Addendum #1

Project: EB Frink Middle School
405 N. Charles Street
LaGrange, NC 28551
Lenior County, NC

Date: March 5, 2024

Item #6: SFL+a Addendum (39 Pages)

2 INT. ELEVATIONS - TYP SCIENCE PREP ROOM NORTH
A-411 SCALE: 1/4" = 1'-0"

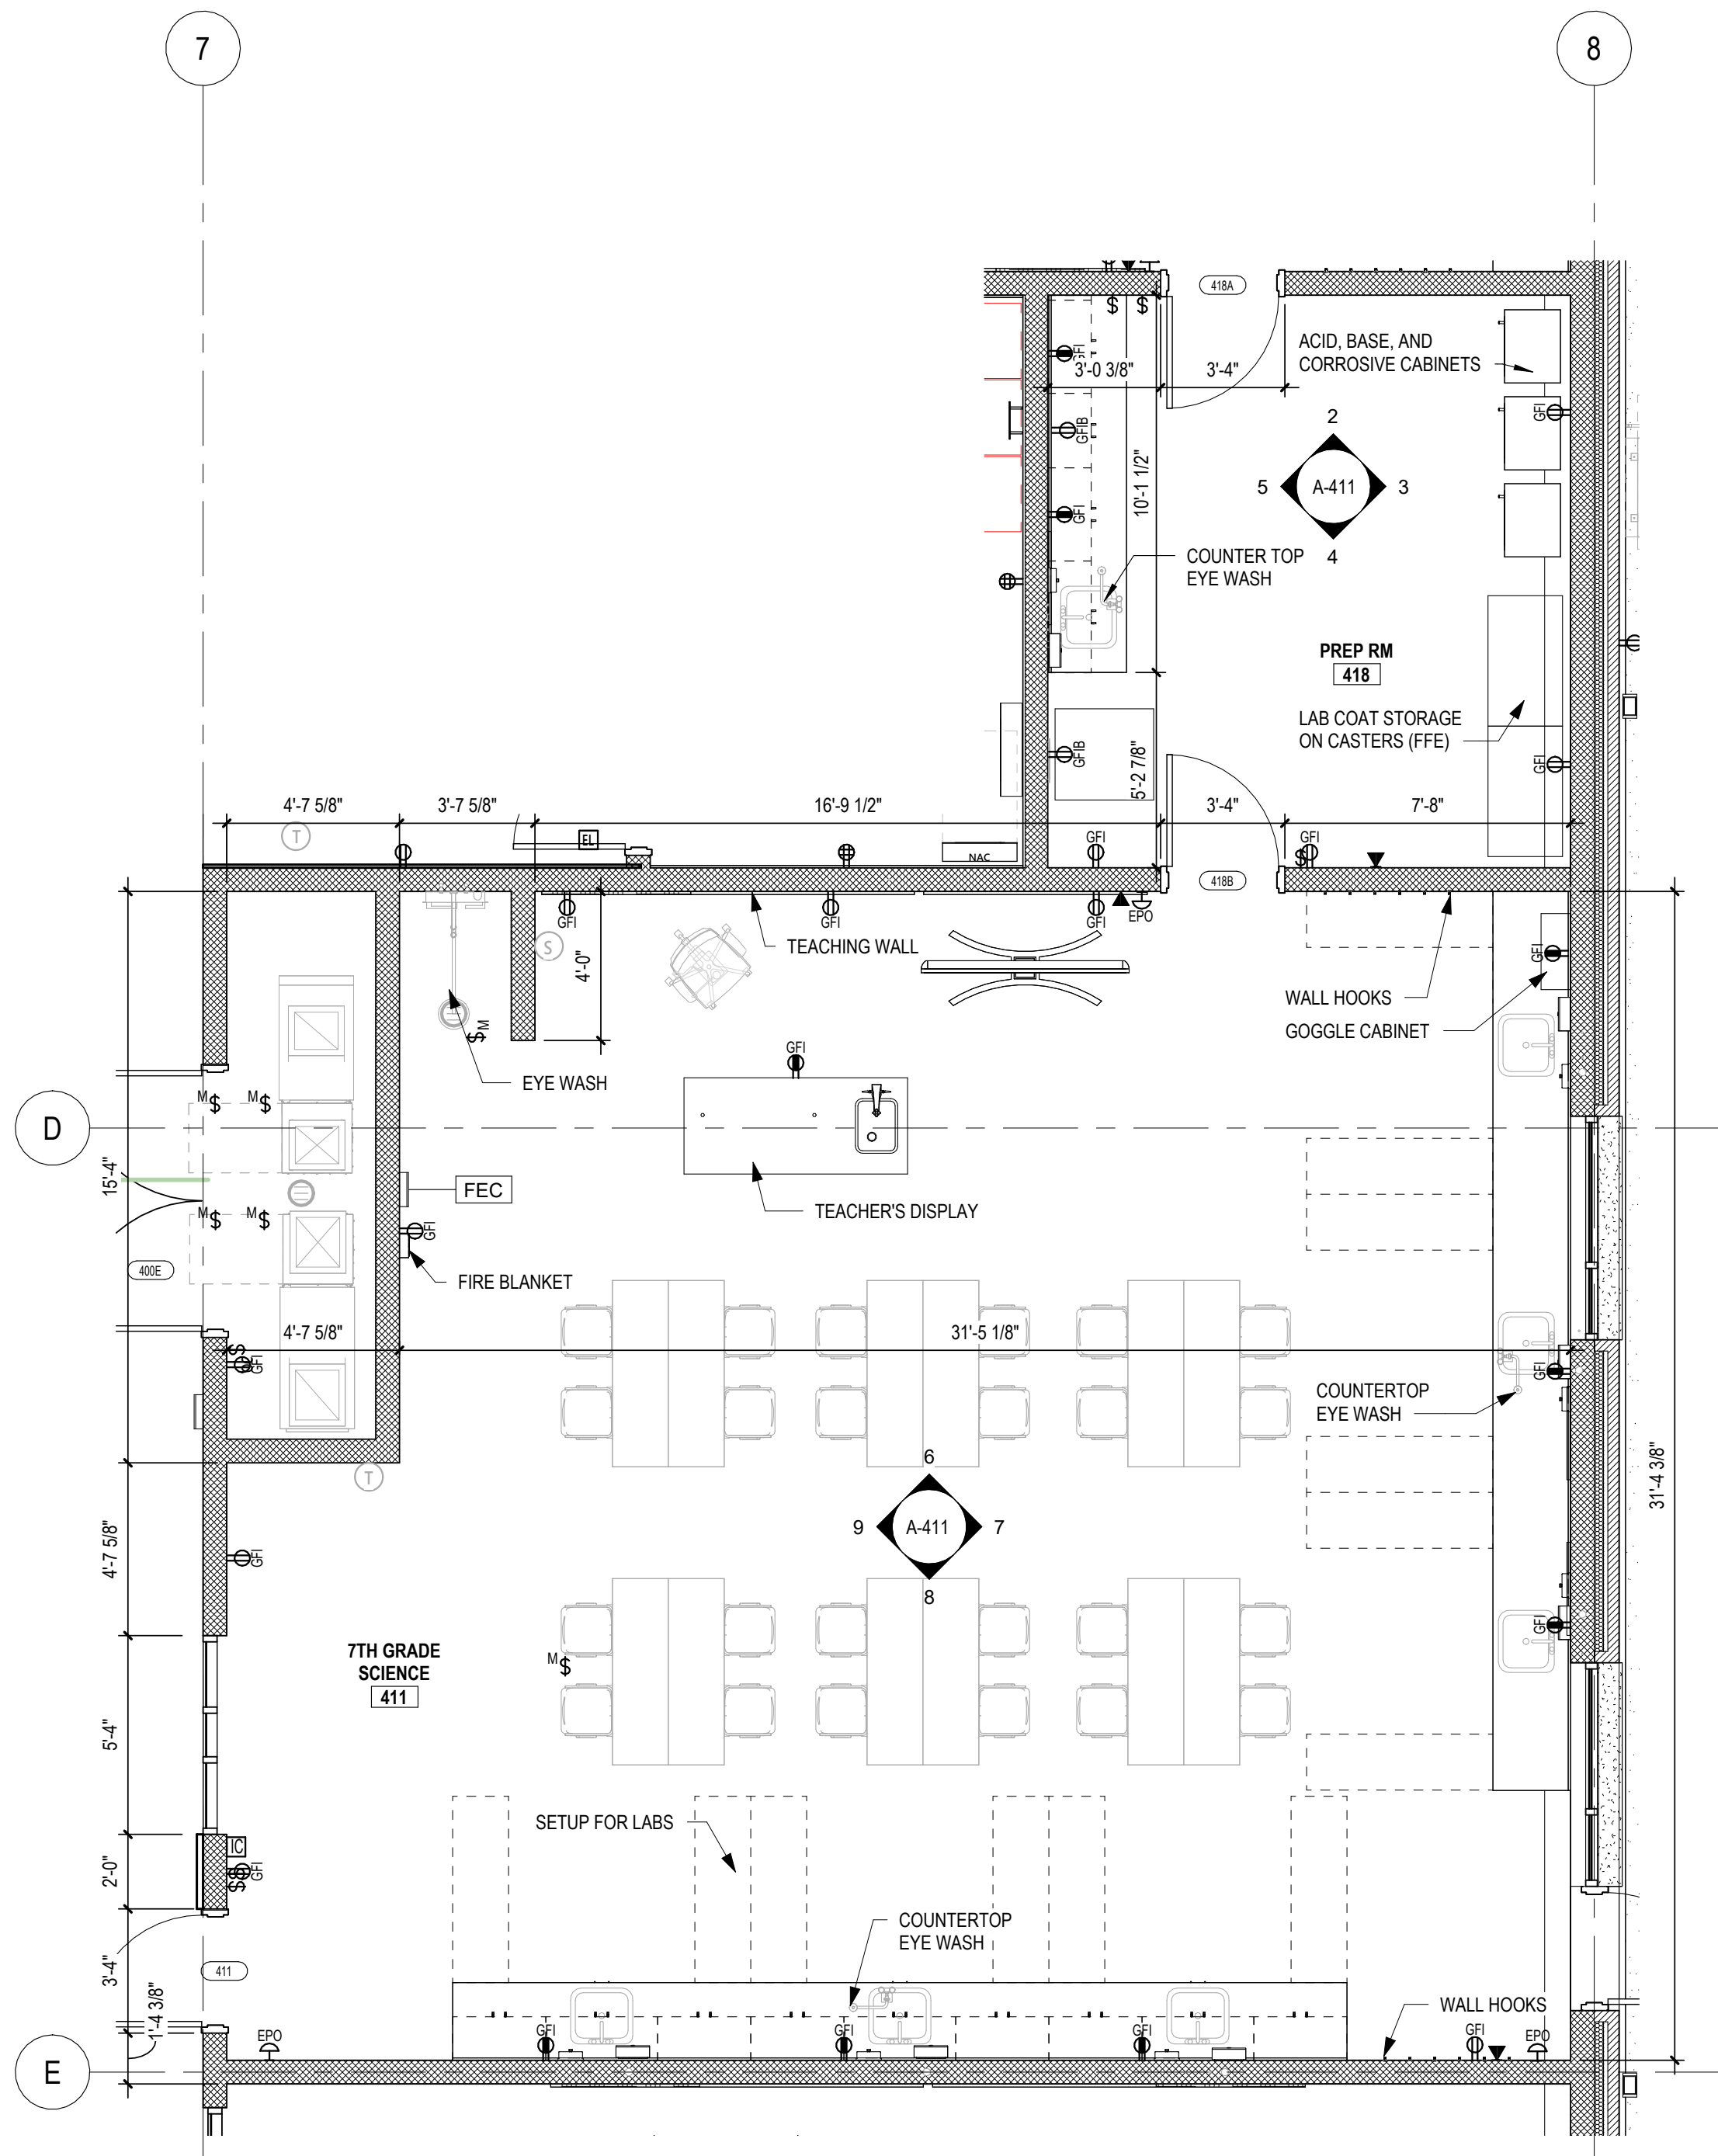
- **Answer: Dimensions shall be coordinated in a forthcoming addendum.**
- Item #9. **Question:** In reference to detail 8 on A-411 the casework does not show a clear dimension off of the adjacent wall. Please provide

- Item #7. A-010:
- L8A6 Wall type removed from sheet.
- Item #9. A-411:
- Dimension added for casework.
- Item #11. A-201:
- Dimensional letters added to exterior.
- Item #20. A-713:
- Flooring revised for eyewash station
- A-714:
- Flooring revised for eyewash station
- A-715:
- Flooring revised for eyewash station
- Item #24. A-711
- Flooring revised for gym storage.
- Item #25. A-432
- Detail 16 removed for clarity.
 - Detail 1: Roof protection removed - not in scope of work.

DETAIL 16
NOT USED

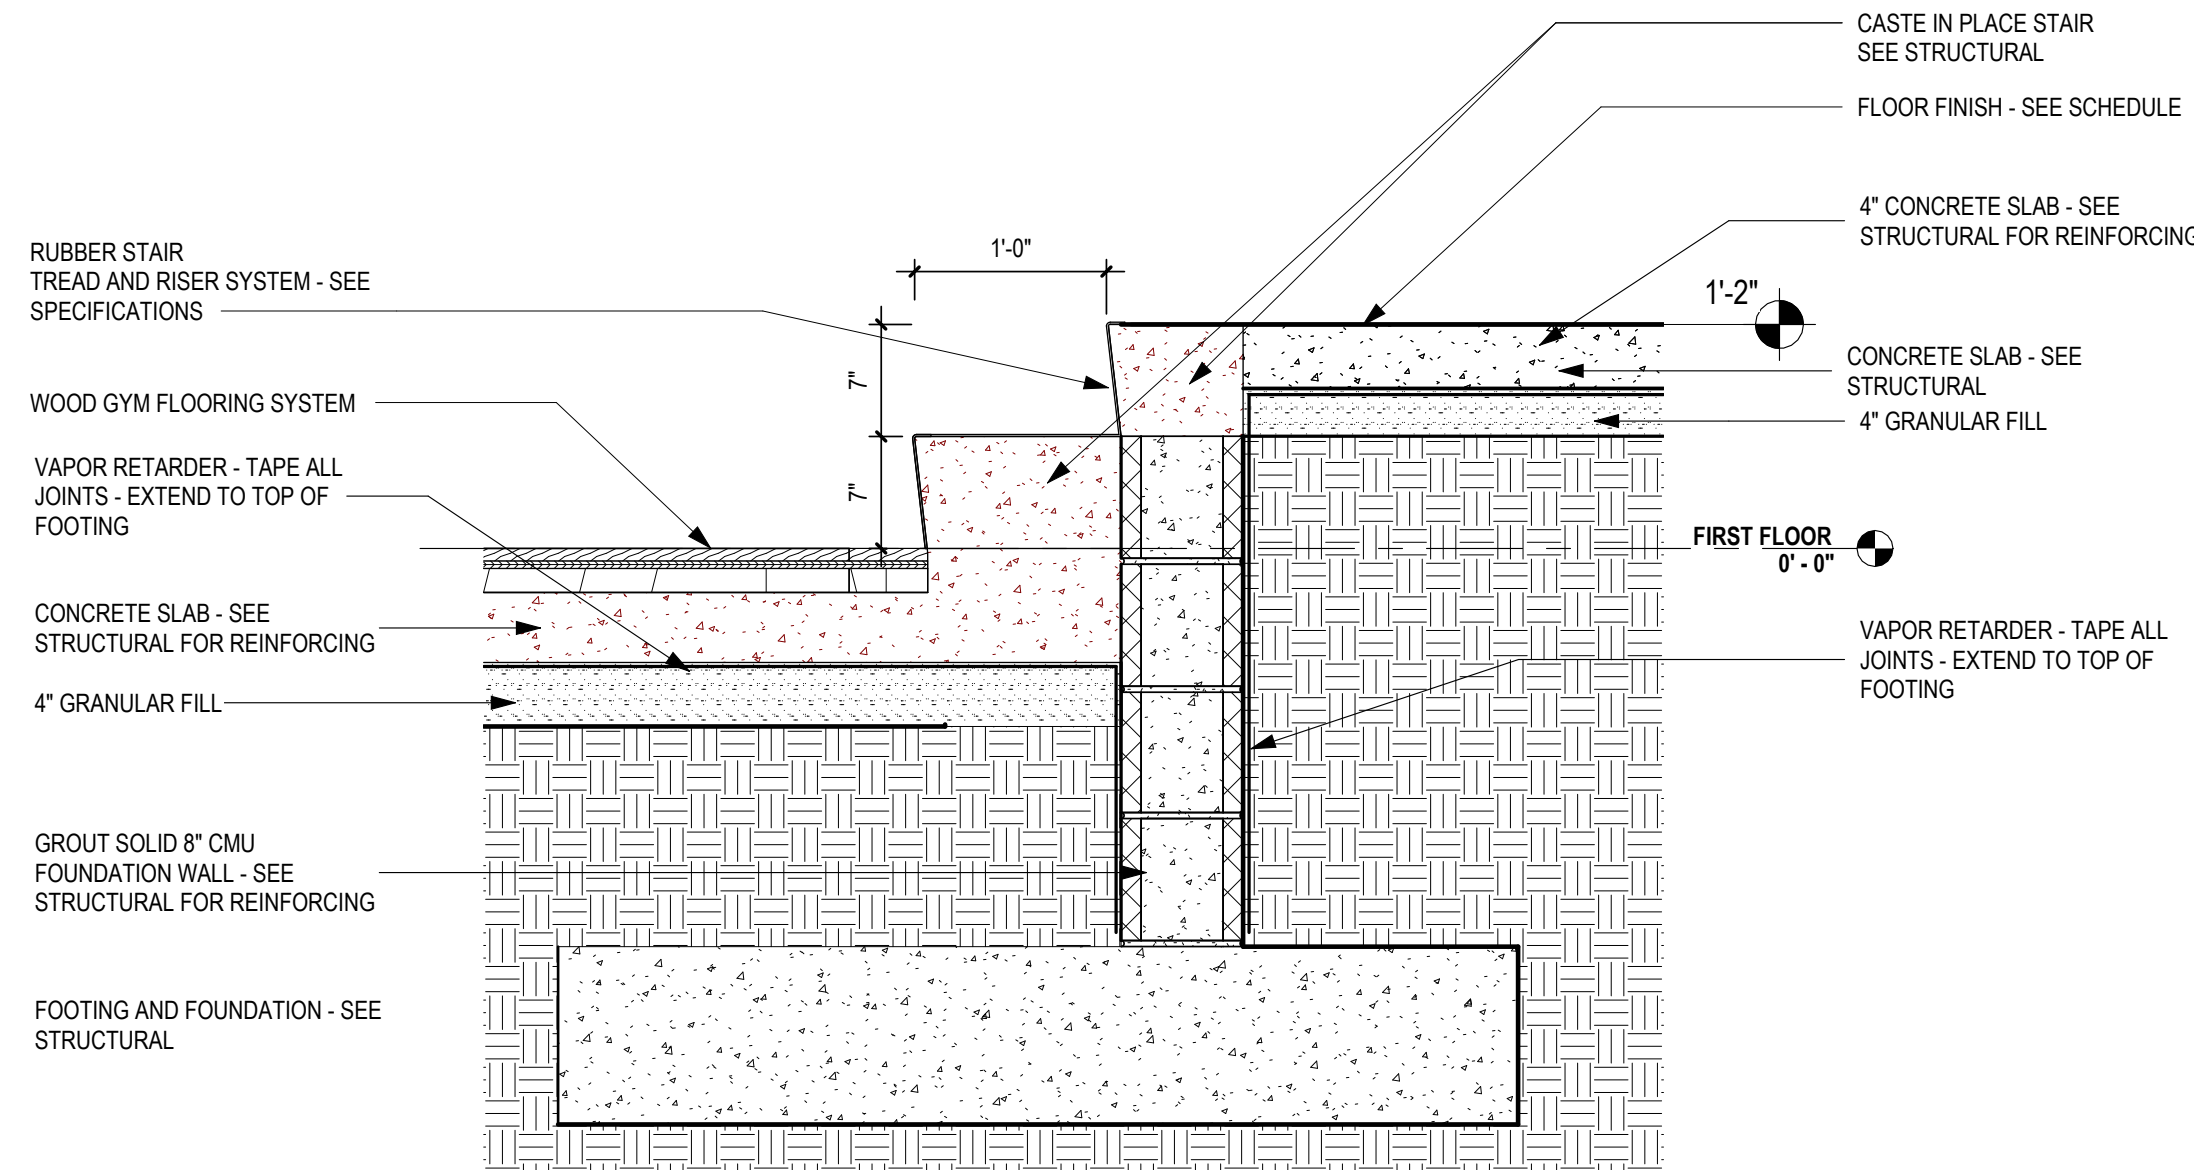
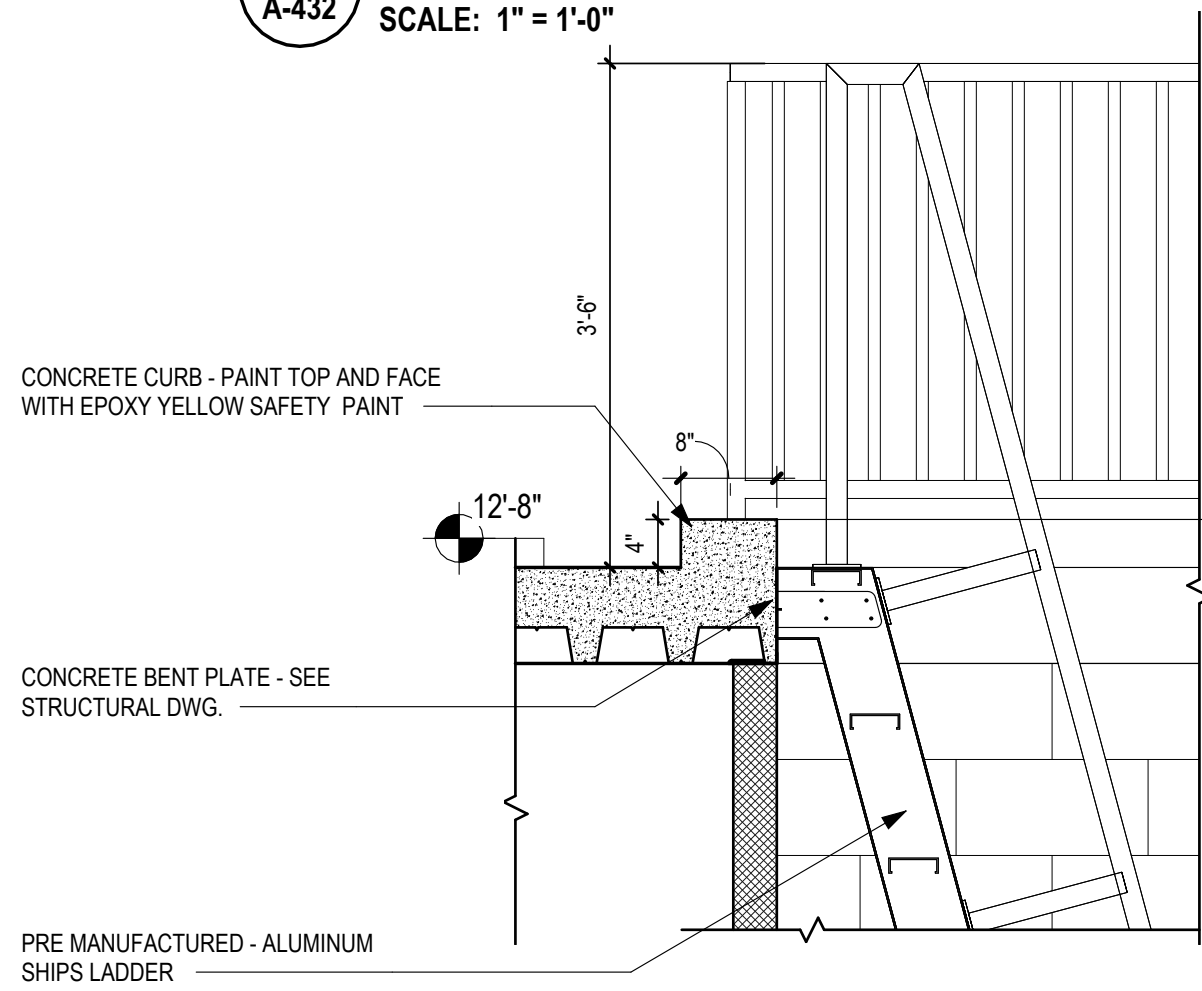
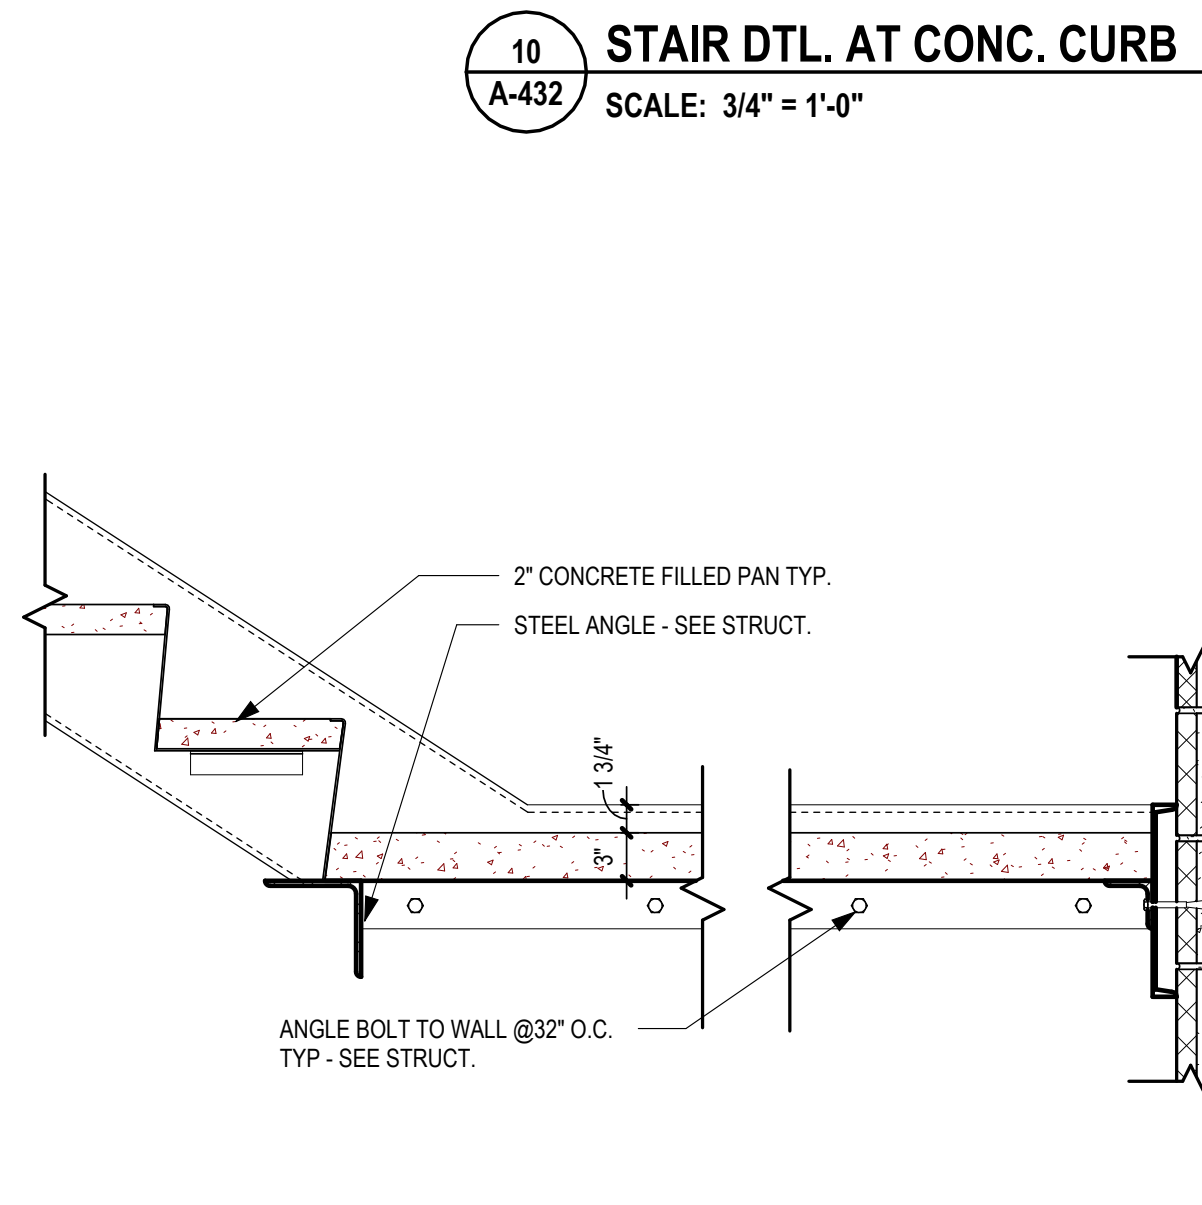
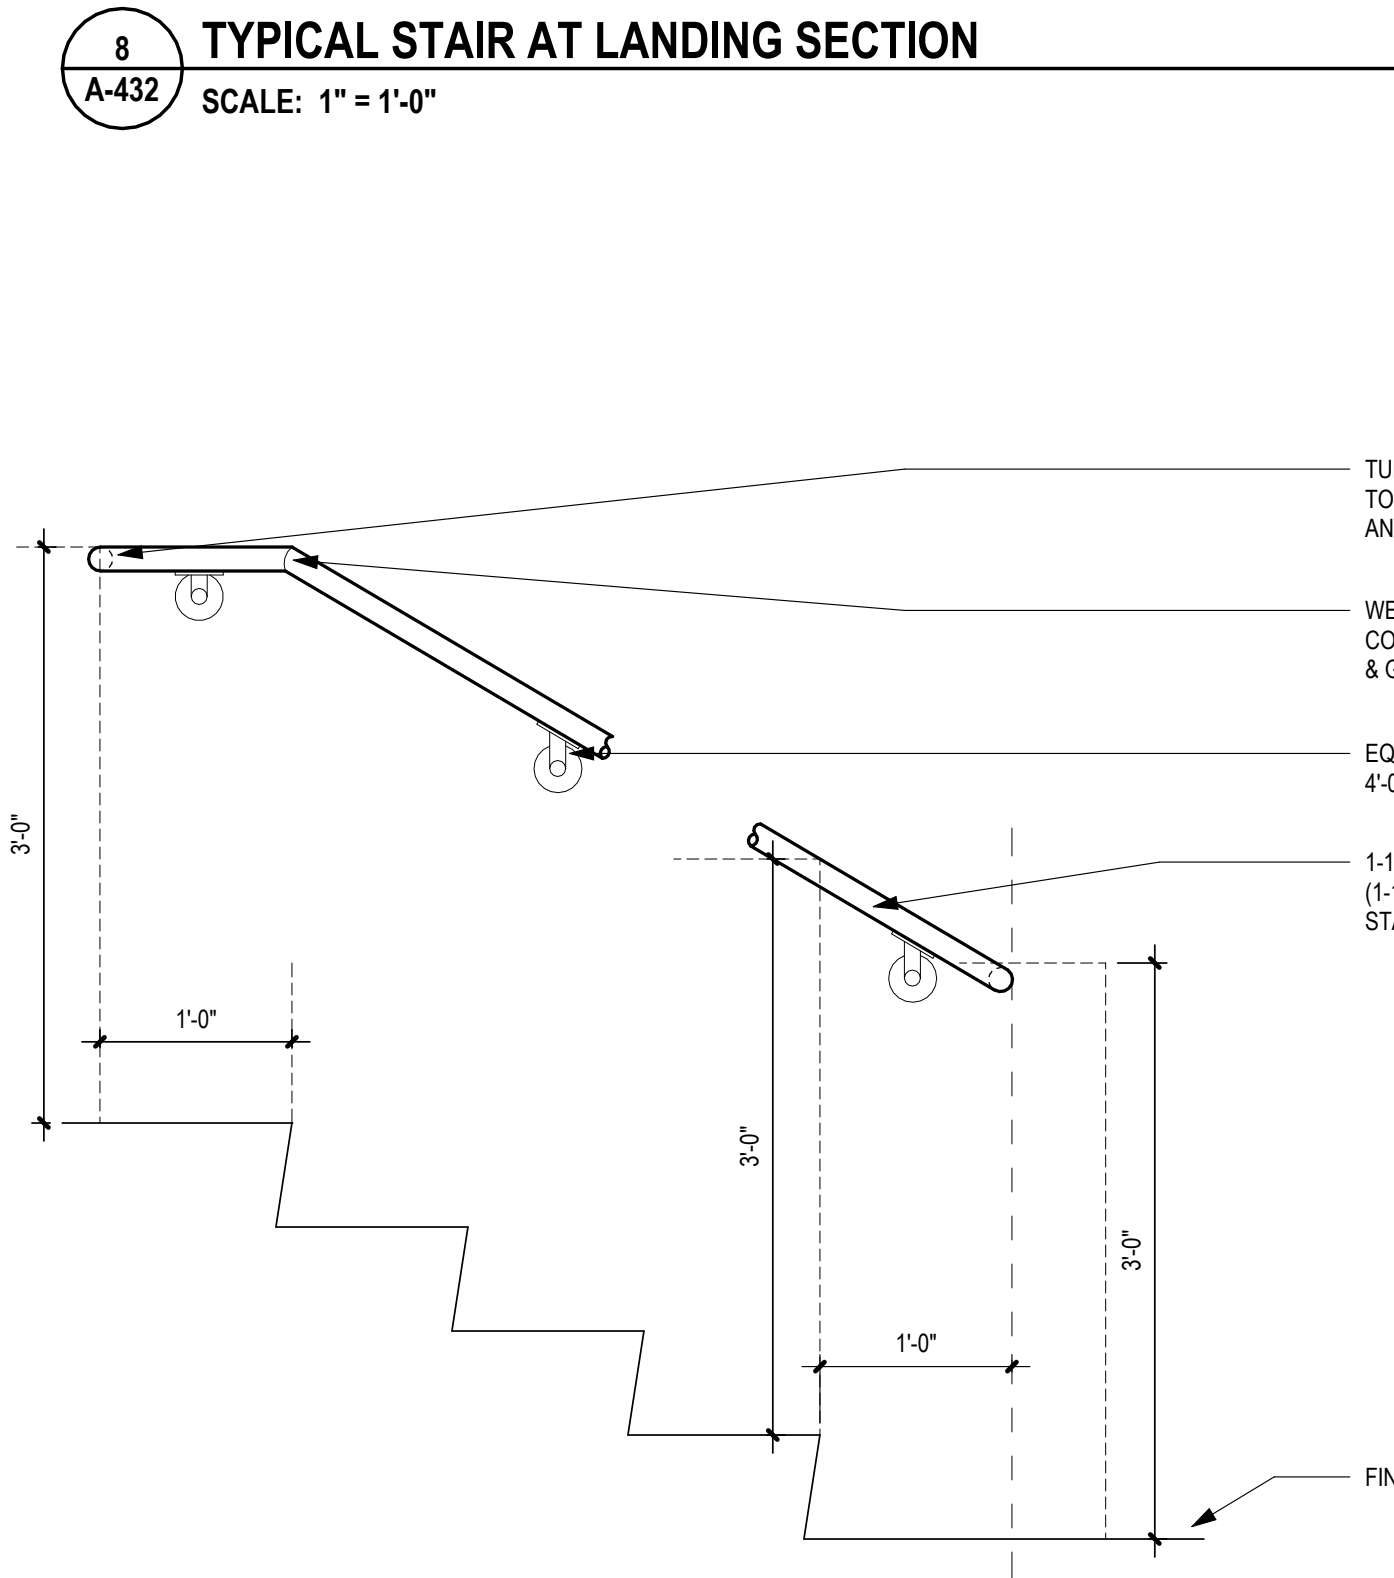
Item #26. Please confirm stair 216 will need RF1 at the mid-landing and rubber treads/risers as noted in detail 16 on A-432.

- ***Answer: Refer to detail 13/A-432 detail for concrete filled pan. Detail 16 has been removed.***

- ***Answer: Detail 16 has been removed. Refer to detail 13 for typical detail. Sealed concrete.***
